Pseudo Random Test Pattern for BER Monitor

Feb. 2005

Katsutoshi SEKI, NEC Electronics

Modified Draft1.3 Figure 55-6

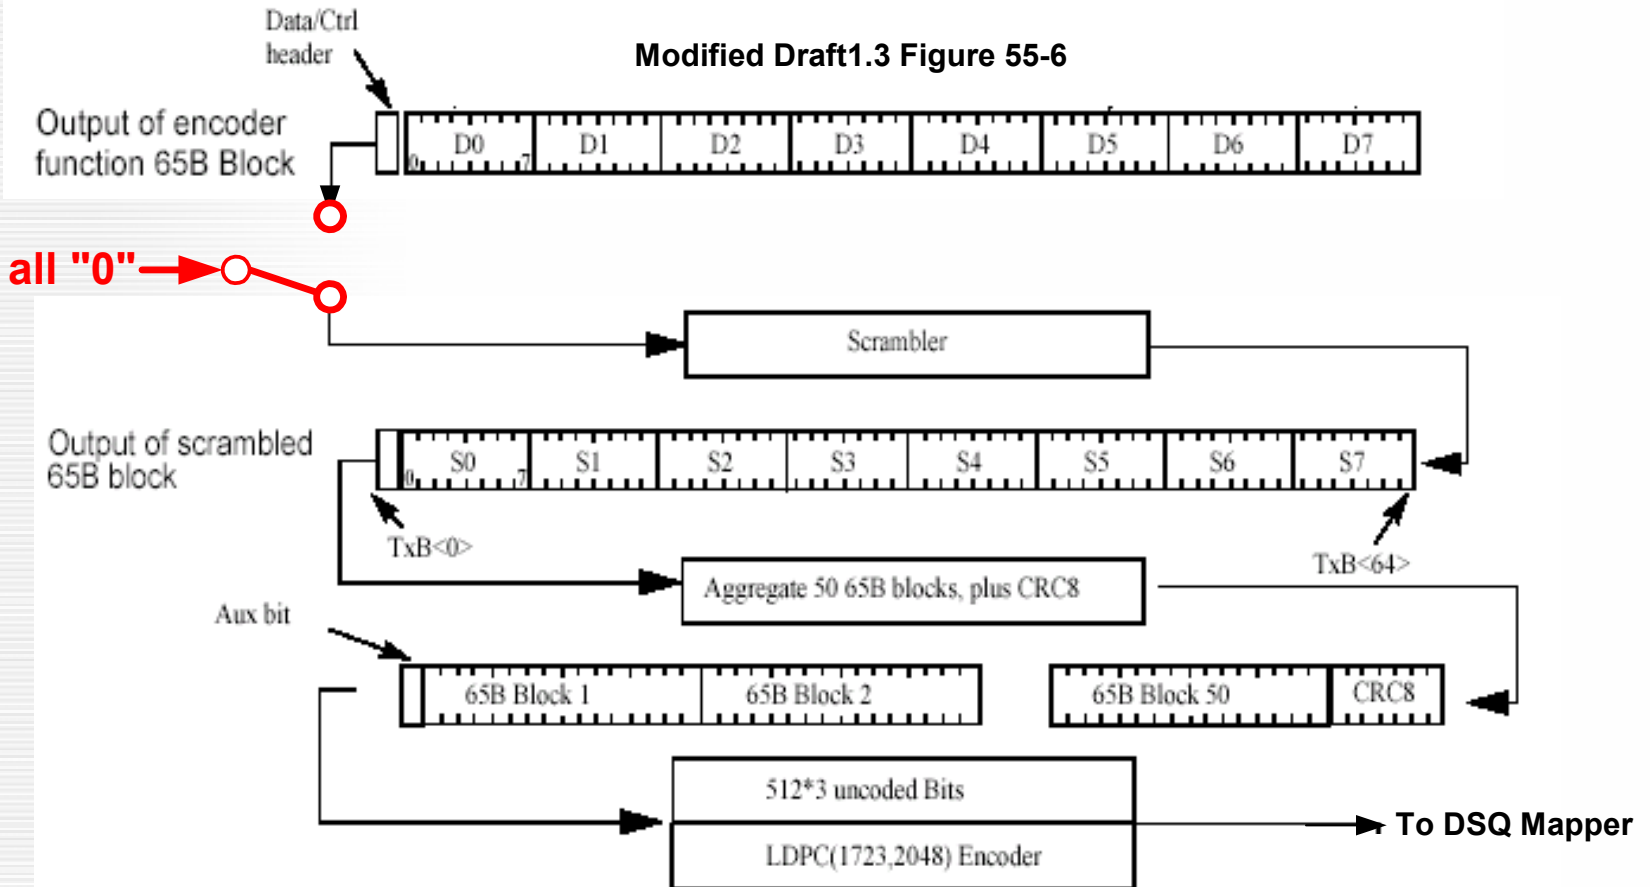
- In pseudo random test mode, all zeros is entered into scrambler
- In no case shall the scrambler state be initialized at all zeros

Modified Draft1.3 Figure 55-7

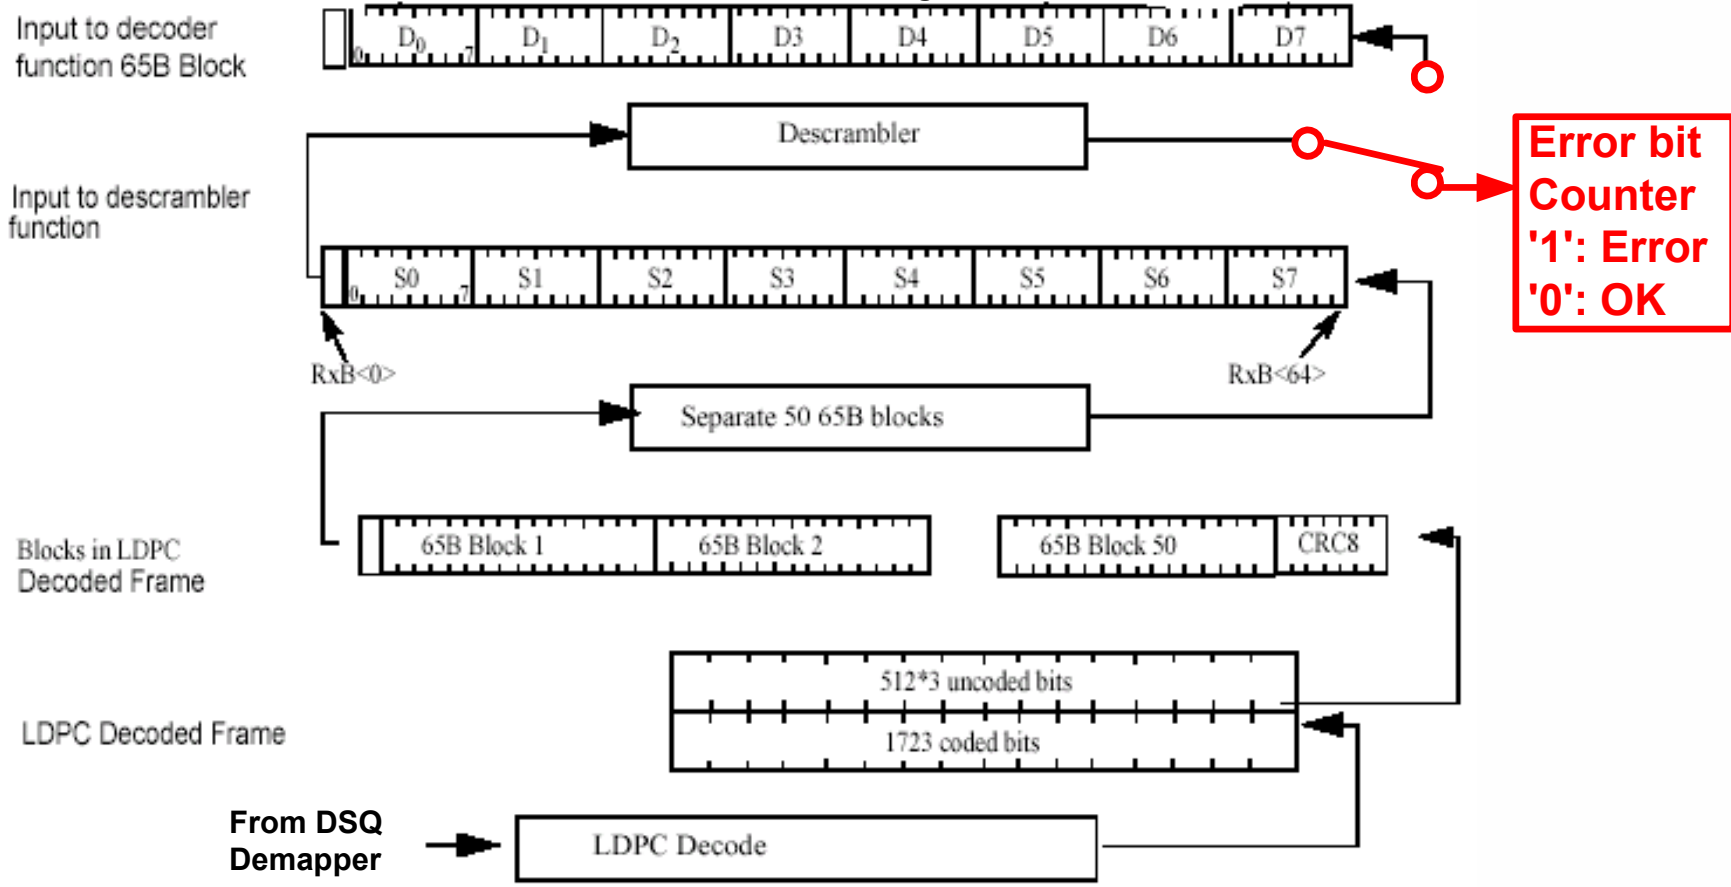
- Error counter can measure the BER of the link including LDPC encoder/decoder, tx and rx AFE and cable
- Reuse 10GBASE-R error counter register (Reg 3.43.15:0)
